## V2500-A5/D5 SERIES PROPULSION SYSTEMS SERVICE BULLETIN

# V2500-ENG-70-0830

INFORMATION – ENGINE – REMOVE ONE OF THE SOURCES FOR THE NO. 3 BEARING

ENGINE - NO.3 BEARING  
Figure 1

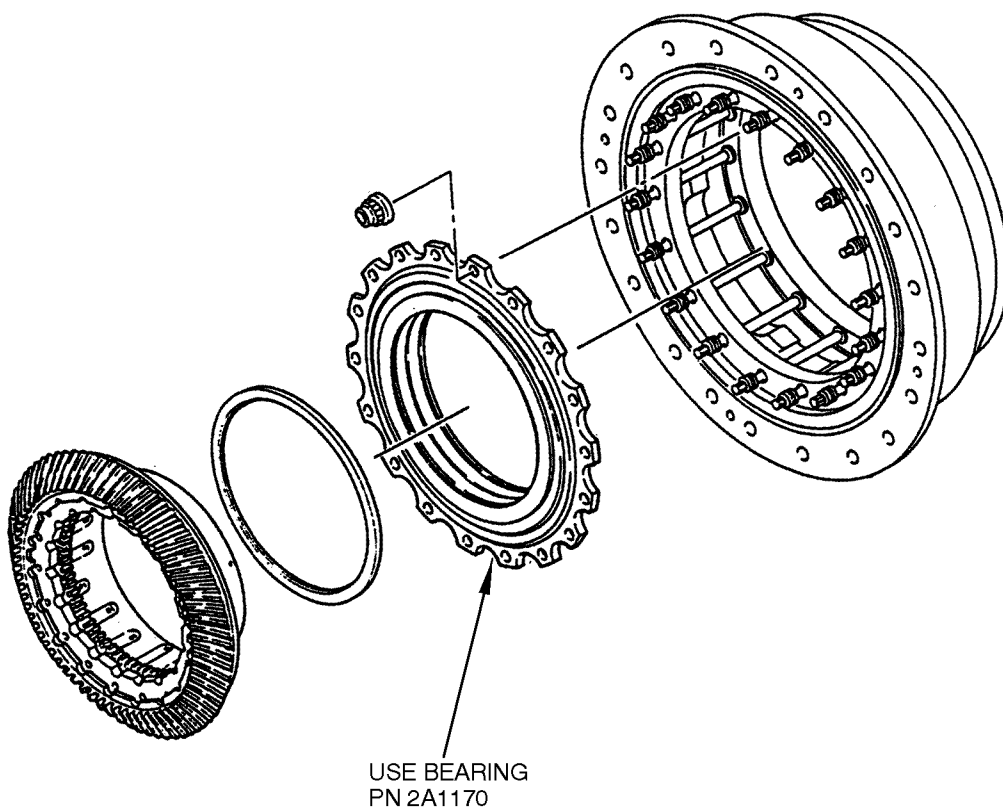
Replace Bearing Option with Detail Bearing.

(01) Bearing Option, PN 2A1250, consists of a Bearing – Ball, Annular, PN 2A1165, or PN 2A1170.
